BURGER KING - STORE #3099 REMODEL

BLOOMINGTON, MN

PL202300039 PL2023-39

① 3D VIEW 1

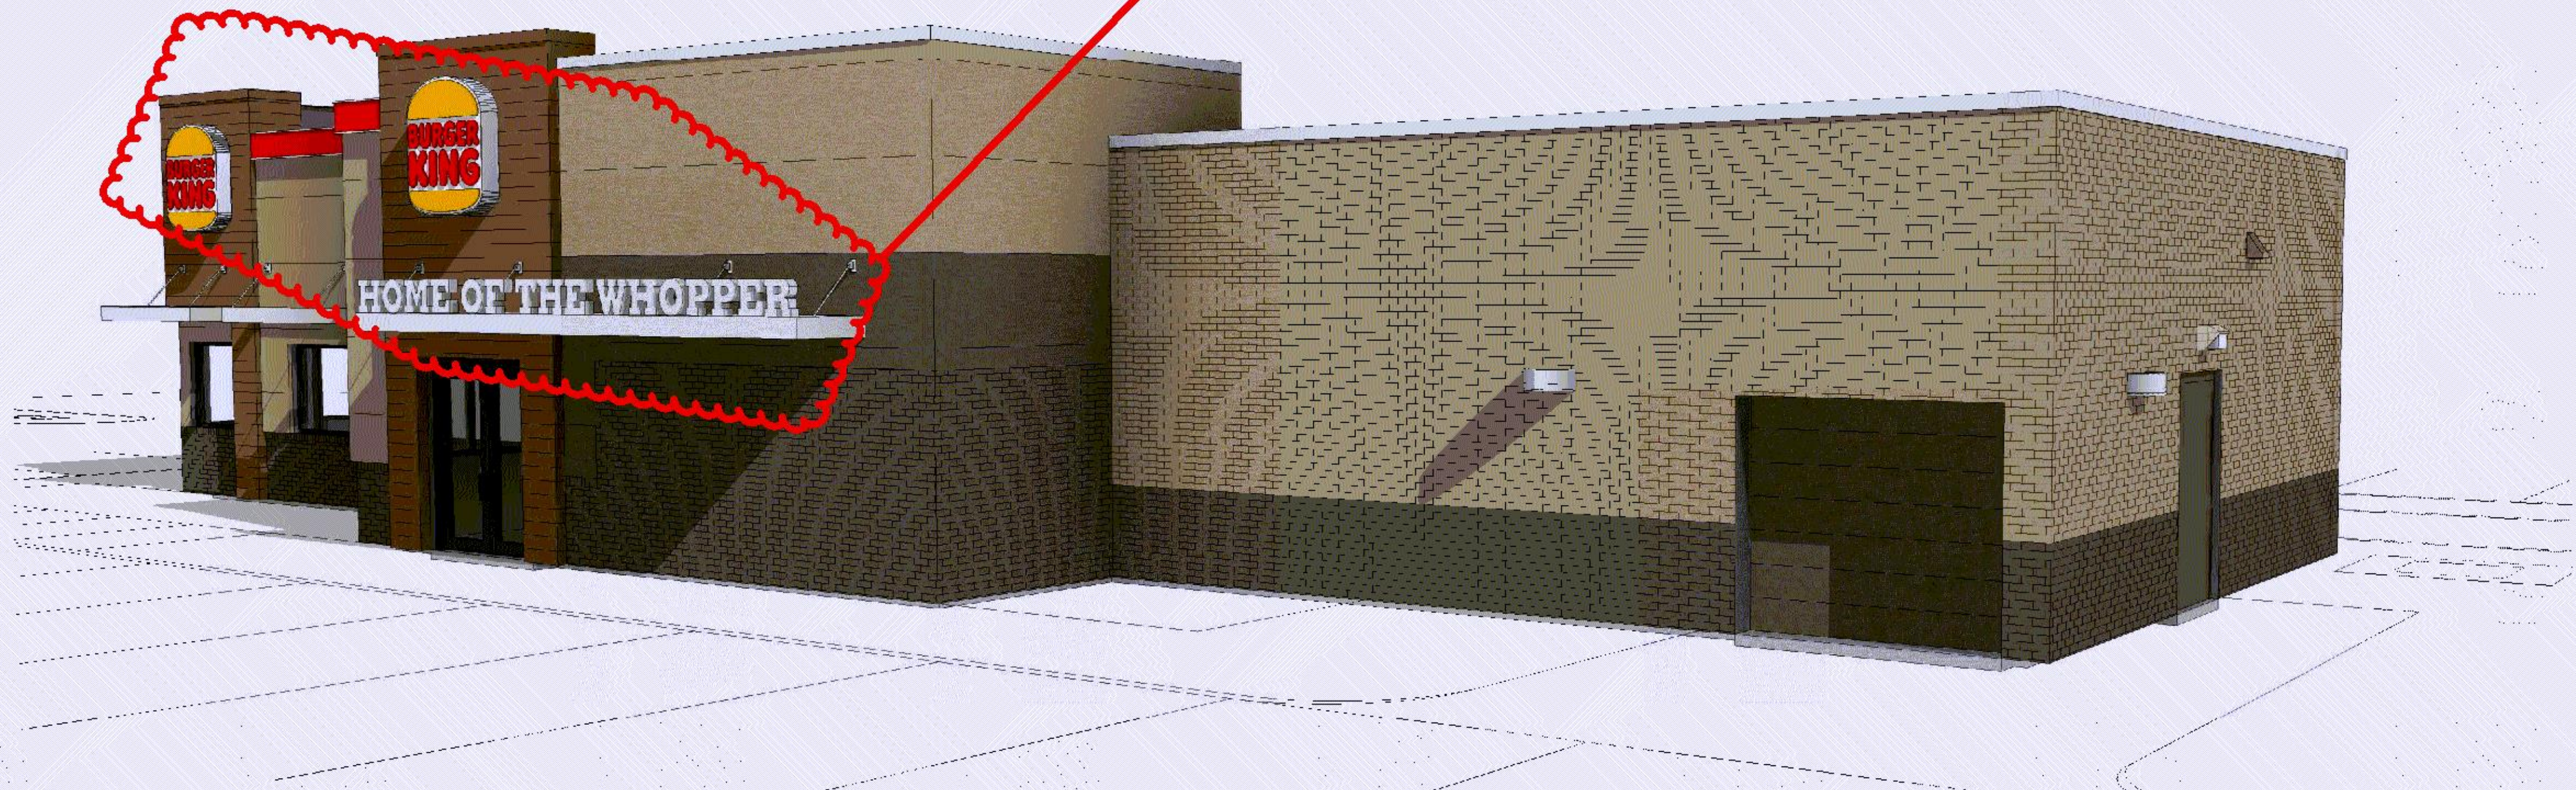
Signs not allowed as shown. Only one cabinet per wall is allowed and individual letters may not be used with a cabinet as the primary sign.
